TULSA METROPOLITAN AREA PLANNING COMMISSION

For Meeting No. 2592
December 15, 2010, 1:30 PM
175 East 2nd Street, 2nd Level, One Technology Center

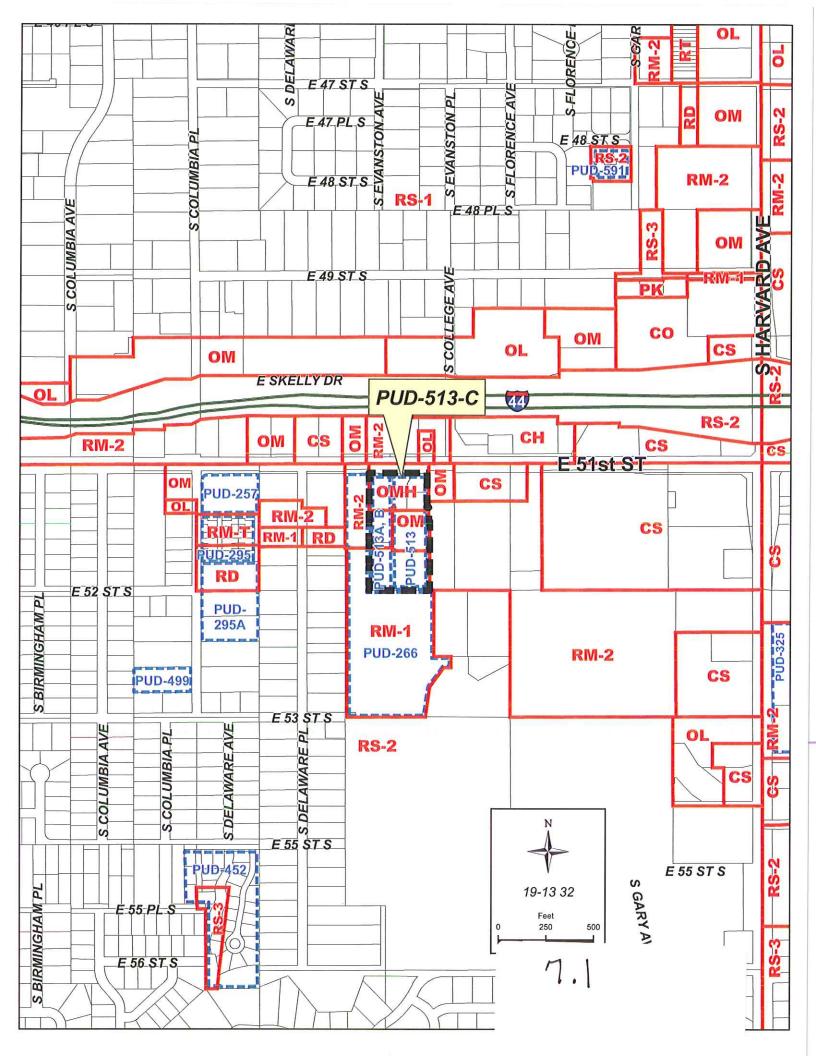
The applicant is requesting a minor amendment to allow unoccupied architectural features up to 65 feet in height. Maximum building height permitted in PUD-513-C is 50 feet. There is no residentially used property adjacent to this PUD.

Please refer to Exhibits A and B. The actual building height of the hotel is 50' with the three unoccupied architectural features reaching a height of 59 feet above grade. The request to allow the features to reach 65 feet gives some flexibility considering the grading work that will be done on the site.

Section 208 of the Zoning Code permits unoccupied features to reach heights up to 20 feet above the height of the building. This includes chimneys, elevators, equipment penthouses, monitors, cooling towers and ventilators. Other building elements such as belfries, clock towers, cupolas, domes, flag poles and spires are allowed up to 150% of the building's height. These unoccupied features will be approximately 9 feet over the height of the building and 18% over the building height.

Staff contends allowing the increase in the height of the architectural features will not substantially alter the development plan, the approved PUD standards, or the character of the development. Therefore staff recommends **APPROVAL** of minor amendment PUD-513-C-1.

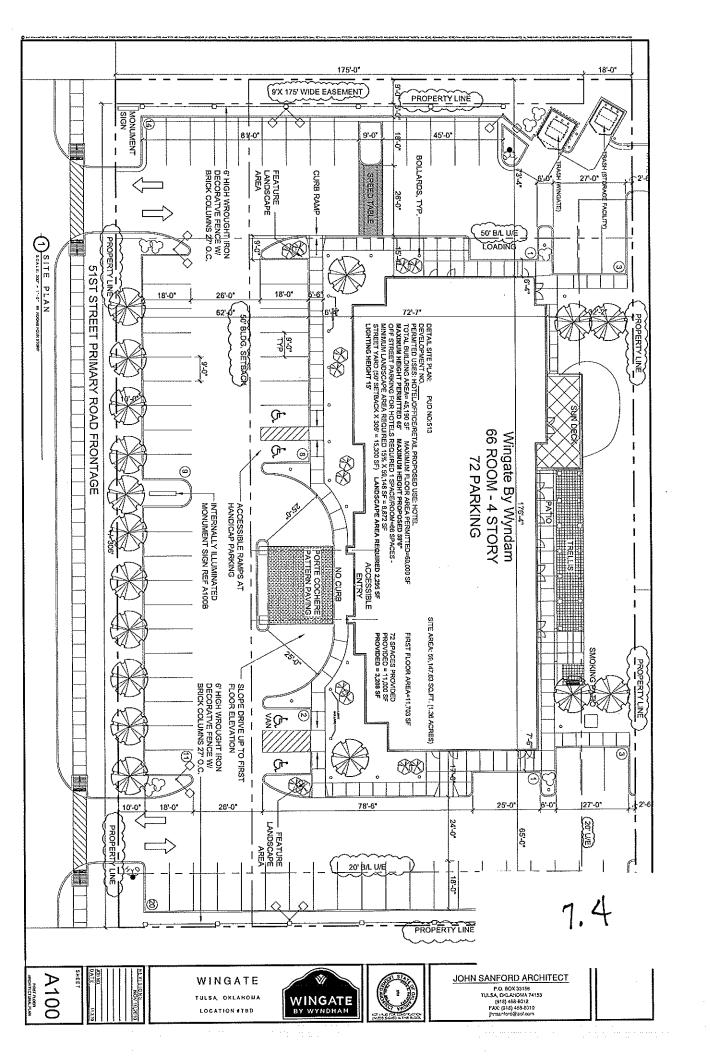
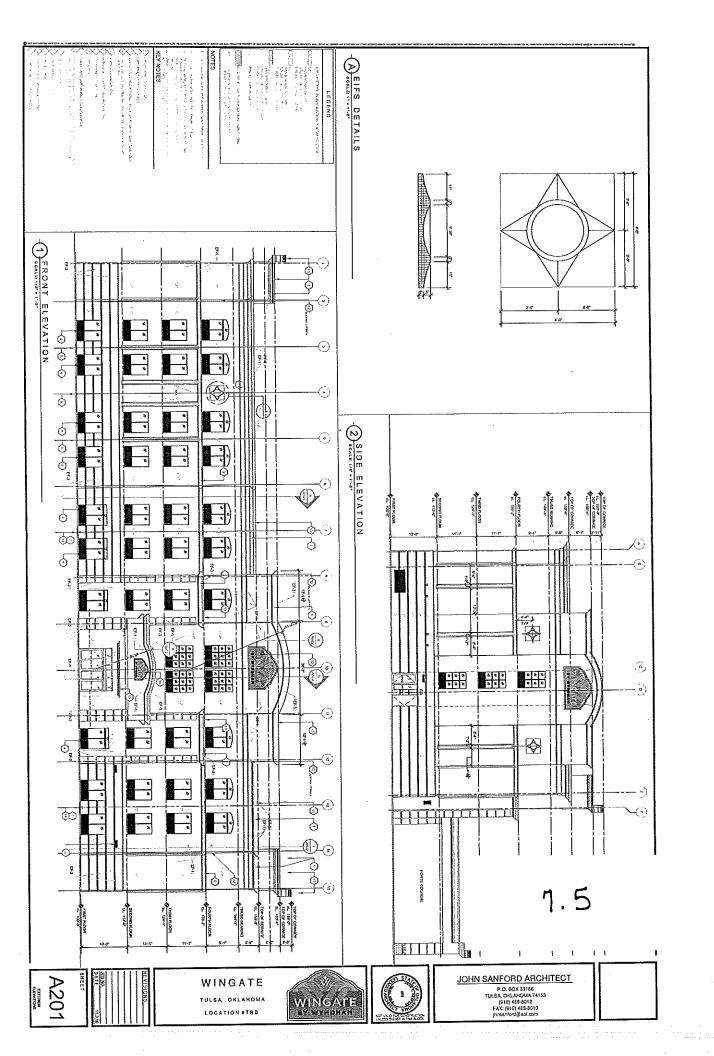
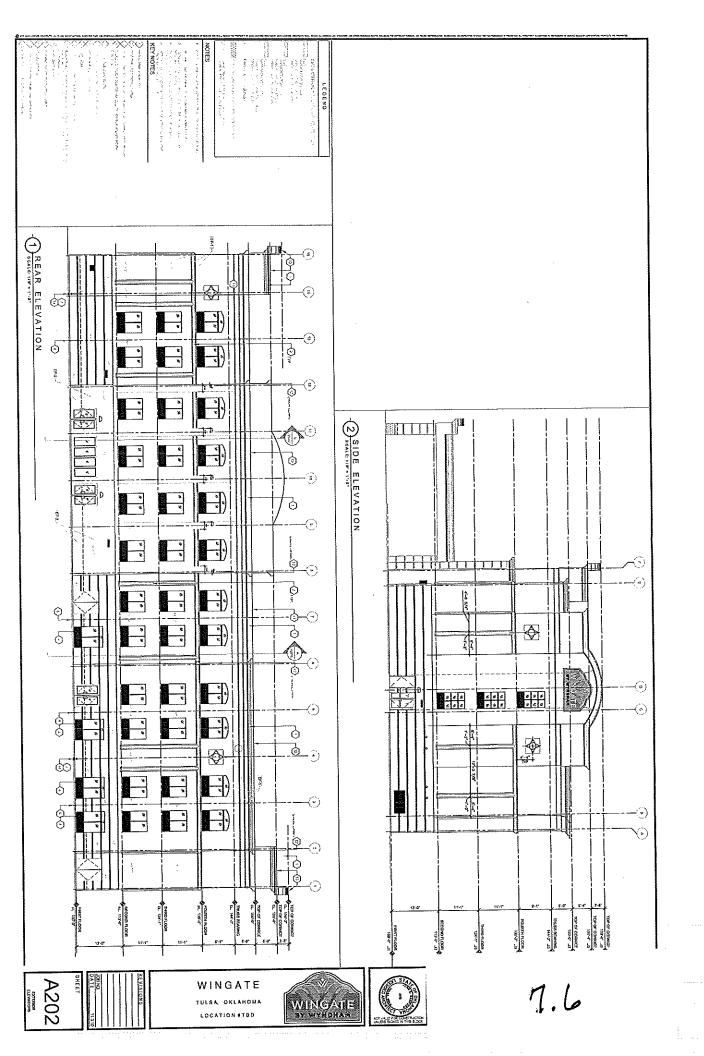
The applicant is requesting approval of a detail site plan for a 45,190 square foot (sf), 4 story hotel. The proposed use, hotel and motel within Use Unit 19 – Hotel, Motel and Recreation Facilities is a permitted use in PUD-513-C. Associated with this detail site plan review is minor amendment PUD-513-C-1, also appearing on the December 15th agenda of the TMAPC.

The submitted site plan meets all applicable building floor area, open space, building height and setback limitations. Access to the site will be provided from 51st Street. Parking is provided per the applicable Use Unit of the Zoning Code. Parking area dimensioning meets the applicable requirements of Chapter 13 of the Code. Landscaping will be provided per the PUD and landscape chapters of the Zoning Code. All sight lighting including building mounted will be limited to 15-feet per PUD limitations for exterior lighting. Lighting will be directed down and away from adjoining properties in a manner that the light producing element and/or reflector are not visible to a person standing at ground level at the perimeter of the PUD. A trash enclosure will be provided and sidewalks will be provided along 51st Street if not existing as required by PUD Development Standards and Subdivision Regulations.

Staff recommends APPROVAL of the detail site plan for PUD-513-C.

EXHIBIT A PAGE 5 OF 5

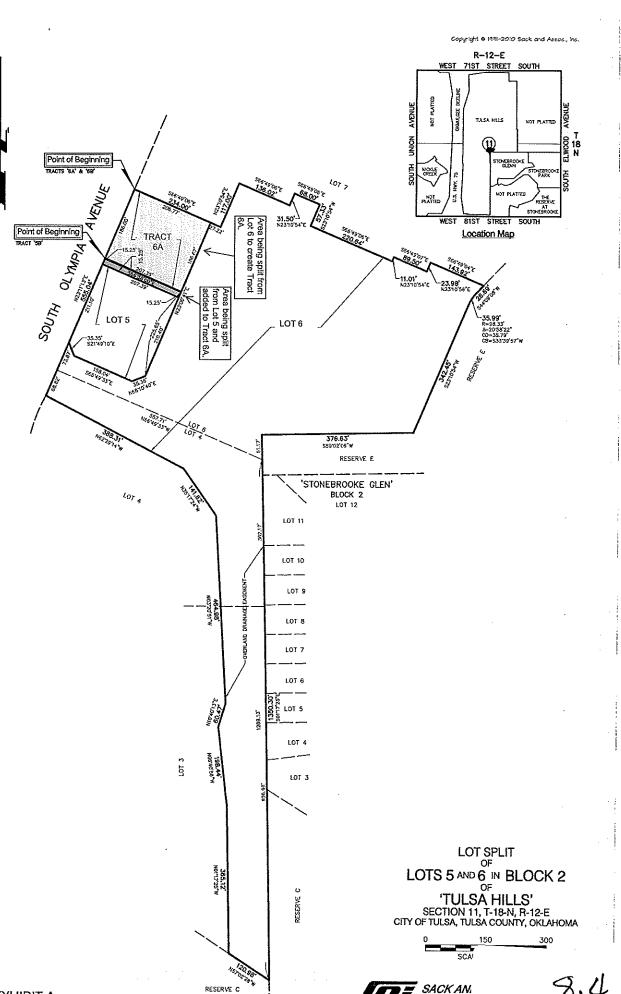
The applicant is requesting a minor amendment to permit a lot split and lot combination requiring a reallocation of existing floor area. With the split and combination is the creation of a new "out-parcel". There is no request to increase the permitted floor area on any of the lots.

Specifically, the applicant is proposing to split 3,162 square feet (sf) from Lot 5, Block 2 and 38,583 sf from Lot 6, Block 2 and combine the parcels to create new Tract 6A as seen on Exhibit A. 10,000 sf of existing floor area will be allocated from Lot 6 to new Tract 6A with no change in permitted floor area for the over-all development area or increase in floor-to-area ratio (FAR). There is no impact expected to adjacent properties as the newly created lot will be adjacent to Olympia Avenue. Floor area is being allocated as follows:

All three lots will remain under the .25 FAR approved for the development area. Staff contends the minor amendment does not represent a significant departure from the approved Corridor Site Plan and recommends **APPROVAL** of minor amendment Z-7008-SP-1q.

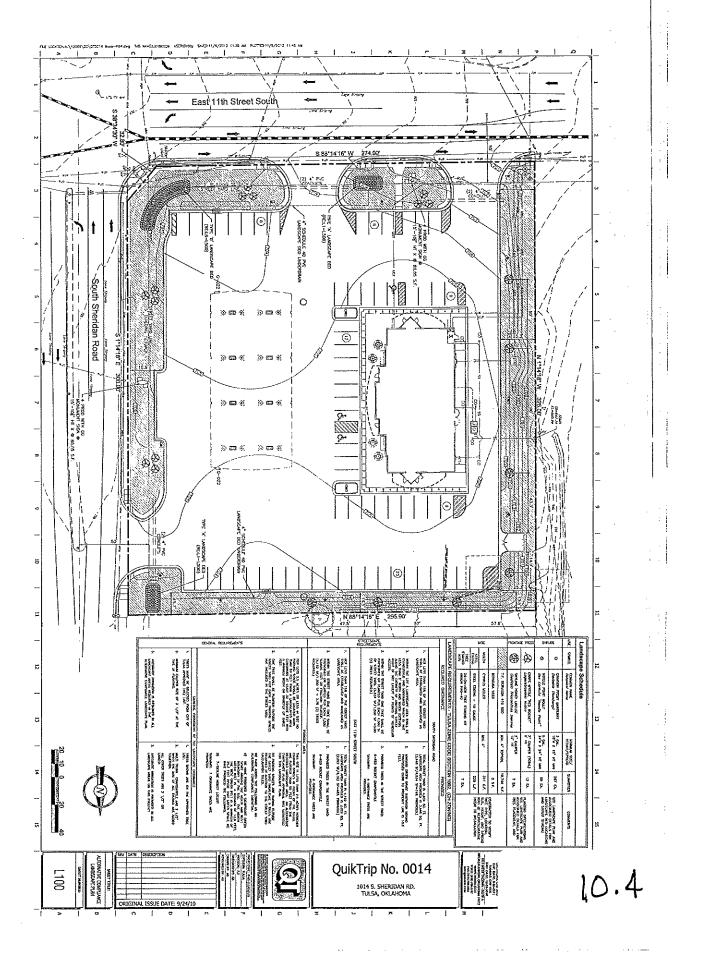
The applicant is requesting approval of an alternative compliance landscape plan for construction of a new QuikTrip® (QT) store. The proposed plan does not meet the technical requirements of Chapter 10 since parking spaces in front of the store are not within 50° of a landscaped area.

Referring to attached sheet L100, the parking spaces which are not within 50' of a required landscaped area are typical of most QT Stores given the long, rectangular shape of the building in relationship to the square nature of their lots. To compensate the applicant is proposing a 13.5-foot to approximately 28-foot wide green belt surrounding the perimeter of the site with five extra trees planted in the street yards. Planting beds are proposed for the south, southeast and northeast corners of the site. The landscape beds will be excessively planted with Crimson Pygmy Barberry and Needle Point Holly miniature evergreen trees.

While the proposed plan does not meet the technical requirements of Chapter 10 staff feels the plan is a vast improvement over existing conditions. Additionally, by providing the extensive green-belt area surrounding the site with extra trees and planting beds, the proposed plan exceeds the technical requirements of Chapter 10. Therefore, staff recommends **APPROVAL** of alternative compliance landscape plan AC-102.
